# RB213-06/07

## Table R602.10.5

## RB214-06/07

### Table R602.10.5, Figure R602.10.5(2)-(New)

FIGURE R602.10.5(2)  
WALLS WITH 6:1 ASPECT RATIO USED WITH CONTINUOUS WOOD STRUCTURAL PANEL SHEATHING

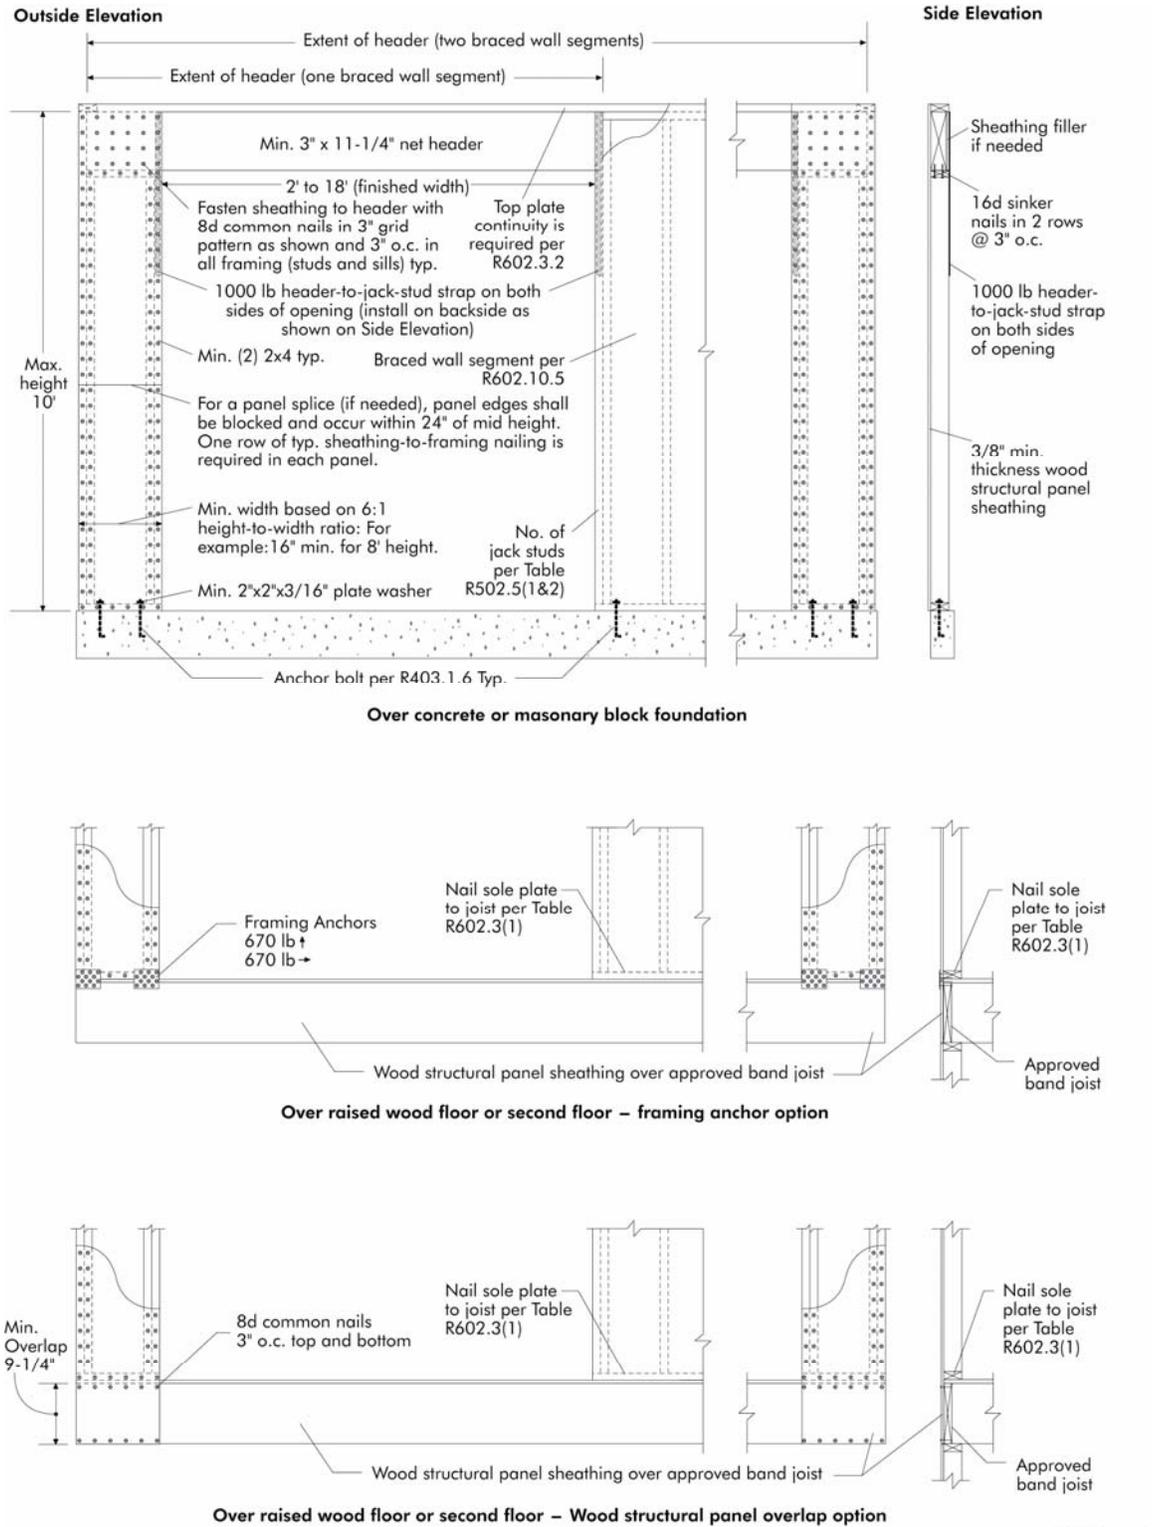
Footnote c currently permits an aspect ratio of 6:1 if a modified version of the portal frame (Section R602.10.6.2) is used in conjunction with wood structural panel continuously sheathed walls. This proposal adds a figure describing the 6:1 aspect ratio wall segment. Previously, the footnote referenced another figure and then enumerated exceptions to that figure, making it difficult to use the provisions.

The proposal also does not limit these provisions to use over a concrete footing at garage openings nor to Seismic Design Categories A-C. Extensive testing has been completed that shows the proposed 6:1 segment performs significantly better compared to existing permitted bracing which can be used in raised floor applications, in all story locations, and in all Seismic Design Categories. More than 50 cyclic tests have been conducted in the last 4 years to support this proposal. Testing has been conducted under a wide range of different boundary conditions, including on raised wood floors with supporting joists parallel and with joists perpendicular to the bracing segment, with solid sawn and engineered joists, with nailed bottom plates, on rigid foundations, with bolted bottom plates, with bottom plate washer nuts finger tight + ¼ turn, with and without any end restraint on the segments, with and without gypsum on the backside of the segments, for braced wall heights of 12-ft, and for braced wall heights of 8-ft. Figures 1, 2 and 3 summarize test results with a low degree of end restraint (no load head, no dead loads, no hold downs, and nuts where used on plate washers were finger tight + ¼ turn).

**Figure 1.** Load-displacement backbone curves of proposed 6:1 bracing compared to existing permitted 4:1 and 2:1 bracing segments. All segments shown were tested with no hold downs, no end restraint and plate washers finger tight plus ¼ turn.

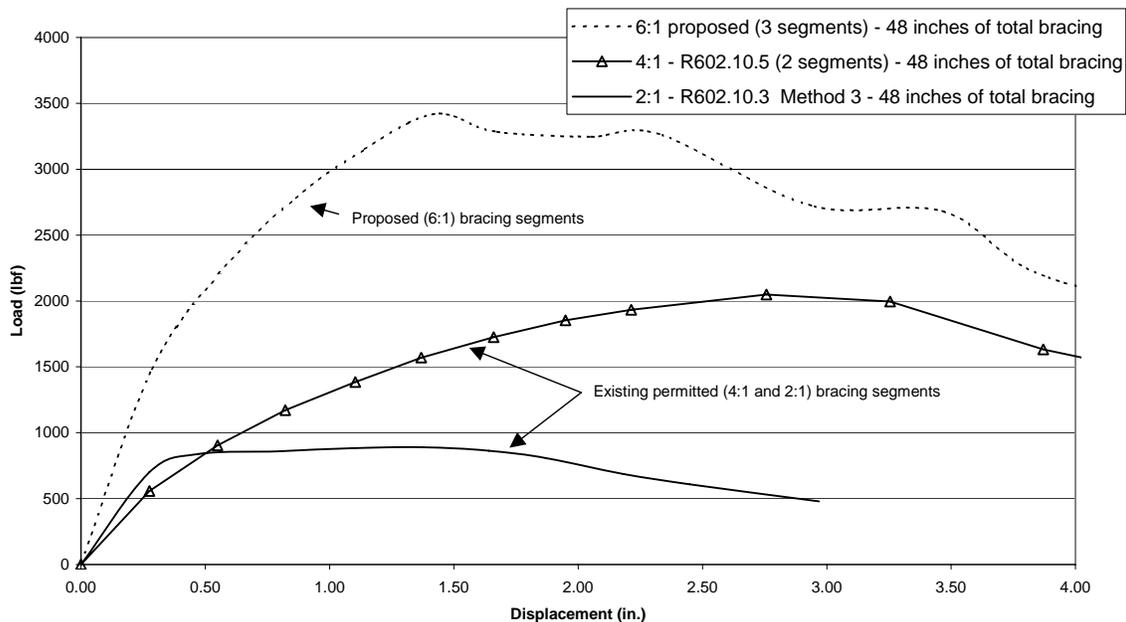
- 1) When equal amounts of bracing are compared, the proposed performs significantly better than currently permitted bracing, as shown in Figure 1. The proposed requires three 16-inch wide segments to equal the same bracing amount as one single 48-inch wide segment or two single 24-inch wide segments.

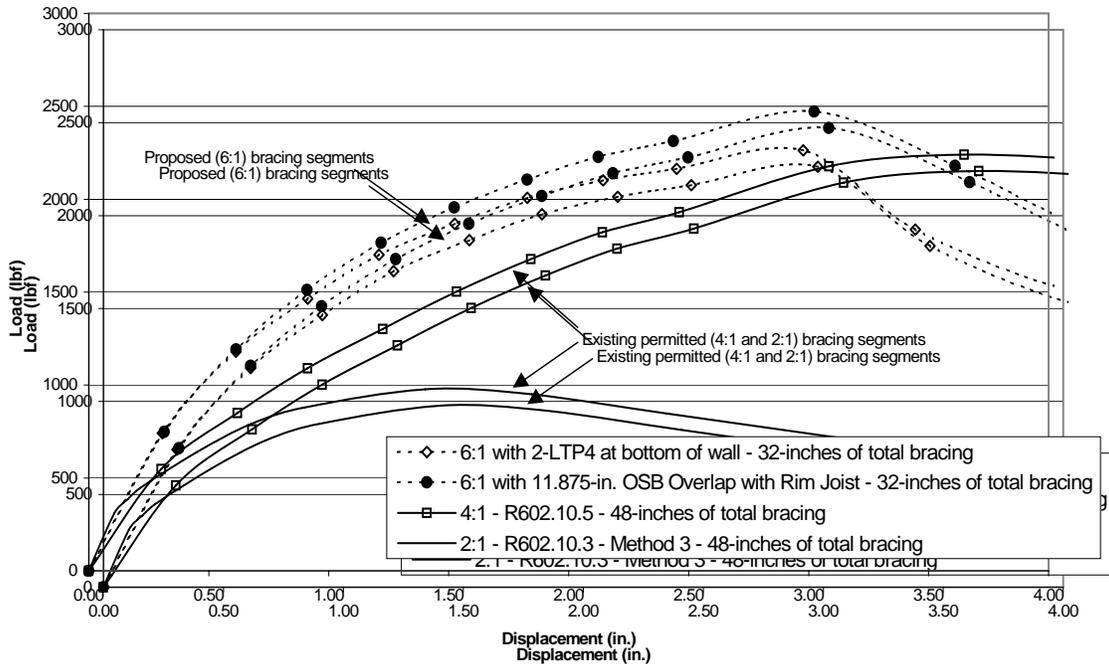
- 2) The performance of only 32" of total bracing of the proposed is approximately equal or better compared to 48" of currently existing permitted 4:1, and 2:1 height to width ratio bracing segments (as shown in Figures 2 and 3).

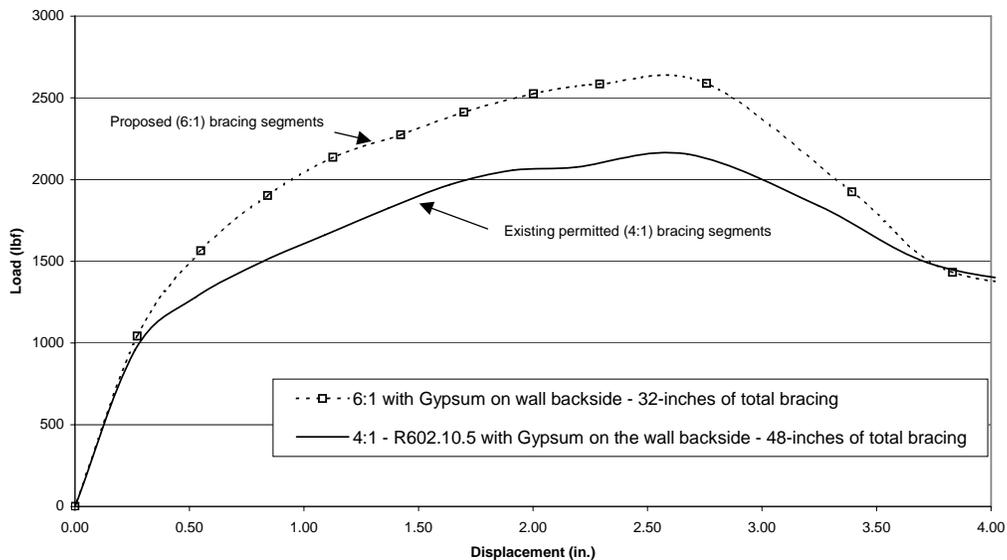
- 3) Testing shown in Figures 1, 2 and 3 uses conservative boundary conditions. If the structure is assumed to impose any degree of end restraint to the wall segments, testing shows that the 6:1 segment improves considerably more than the existing permitted 4:1.

**TABLE R602.10.5(1)**  
**HEADER TO JACK STUD STRAP AND THE NUMBER OF ADDITIONAL JACK STUDS REQUIRED FOR RESISTING**  
**WIND PRESSURES PERPENDICULAR TO 6:1 ASPECT RATIO WALLS LOCATED IN WIND EXPOSURE CATEGORIES C AND D**

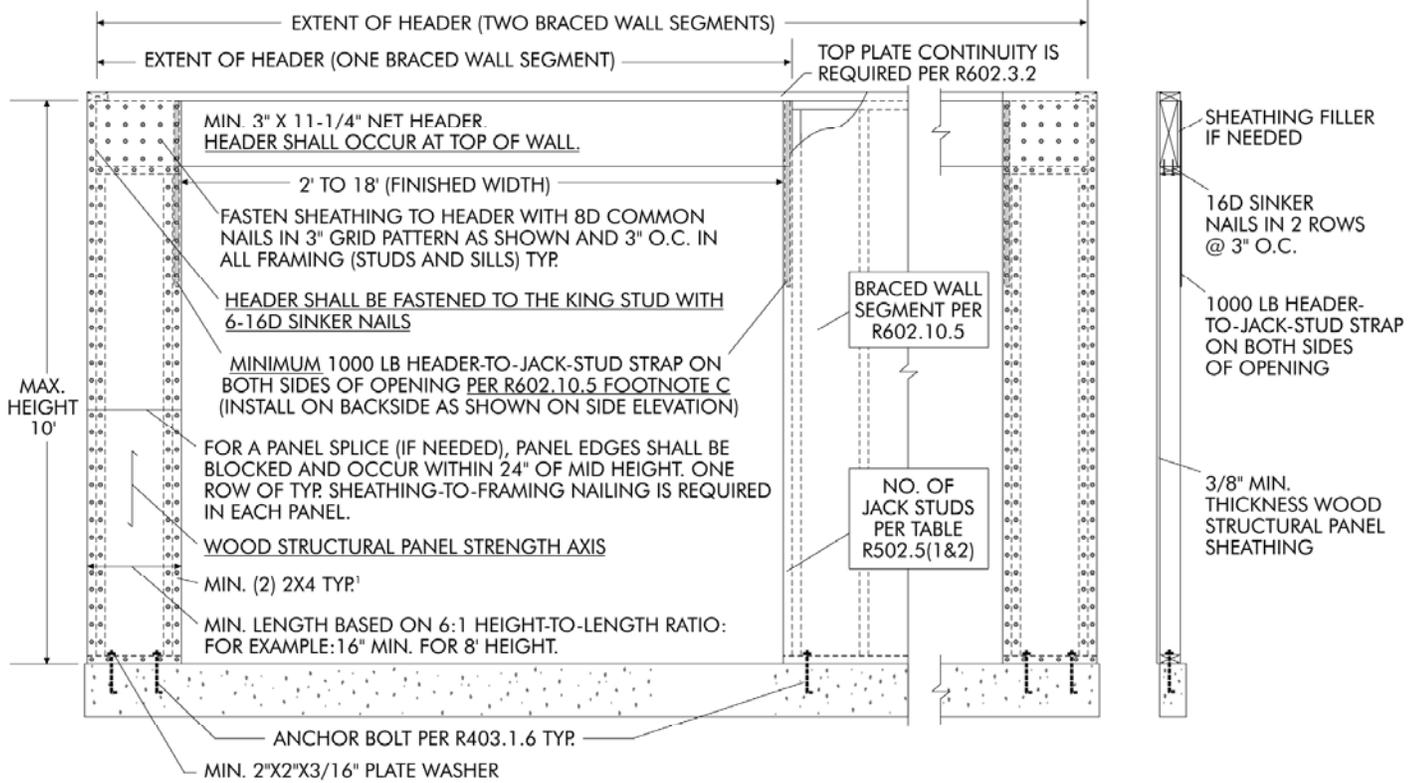
**Commenter's Reason:** The ICC Ad Hoc Committee on wall bracing deemed it important to ensure that the 6:1 aspect ratio bracing segment framing be capable of resisting design wind pressures acting normal to the wall surface (acting perpendicular to the wall) before support is given to code change RB214-06/07. This modification adds requirements so that the required framing for the lateral bracing segment is capable of resisting design wind pressures acting normal to the wall surface.

shall be equal to its measured width. For purposes of resisting wind pressures acting perpendicular to the wall, in accordance with Section R301.2, the minimum requirements of Figure R602.10.5(2) shall be sufficient for wind speeds less than 110 mph in Exposure Category B. For Exposure Categories C and D, the header to jack stud strap requirements and the number of additional jack studs shall be in accordance with Table R602.10.5(1).

a. If 2x6 framing is used, then the required strap capacity may be multiplied by 0.65, but in no case shall the required strap capacity be less than 1000 lb.

b. If 2x6 framing is used, then no additional framing shall be required.

**FIGURE R602.10.5(2)  
WALLS WITH 6:1 ASPECT RATIO USED WITH CONTINUOUS WOOD STRUCTURAL PANEL SHEATHING**

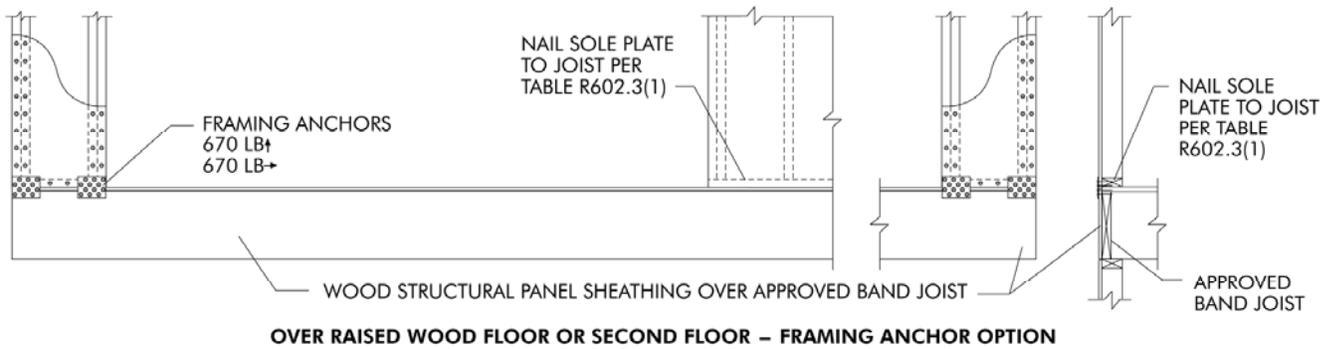
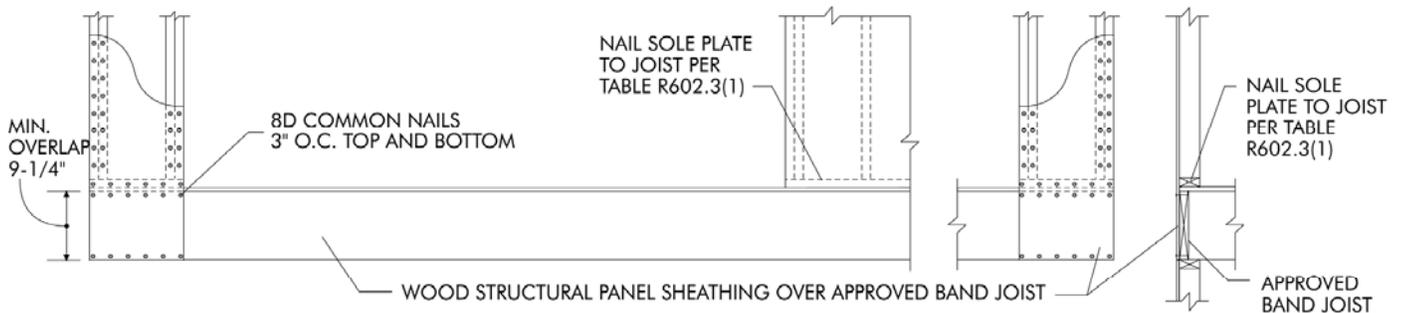
Engineering analysis was performed to determine the capacity of the 6:1 aspect ratio bracing segment framing to resist wind pressures normal to the wall surface. The load demand is based on wind pressures in Table R301.2(2) and Table R301.2(3) for worst case conditions, zone 5 wind pressures, and 30-foot mean roof height. Results of the engineering analysis have been reviewed and supported by the ICC Ad Hoc Committee on wall bracing.

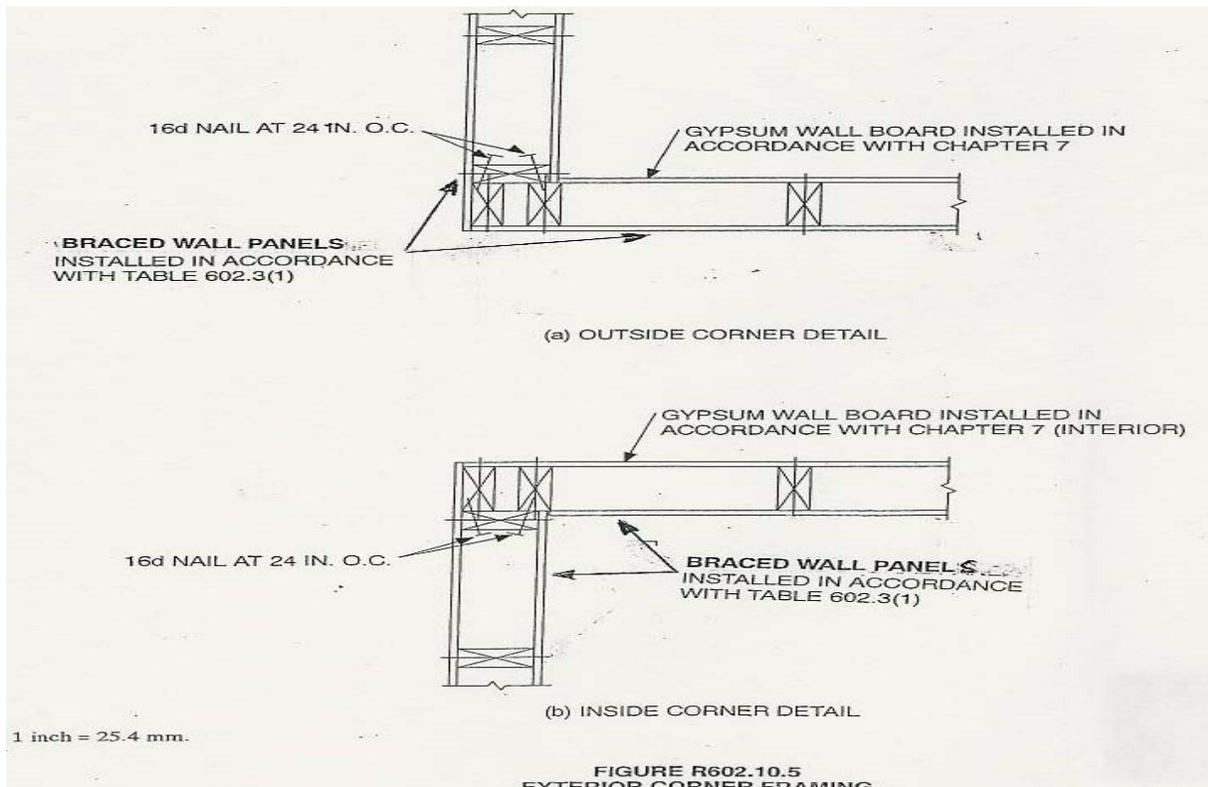
A coordinated change to Figure R602.10.5 is submitted to broaden the use of the figure for fiberboard structural panel sheathing and wood structural panel sheathing braced wall panel construction method.

**Committee Reason:** Figure R602.10.5 implies that gypsum board must be used and the committee feels that other materials should be allowed. There are issues that were identified in the failed modification and this should be reworked into a full complete package and brought back to give ample time for full review.
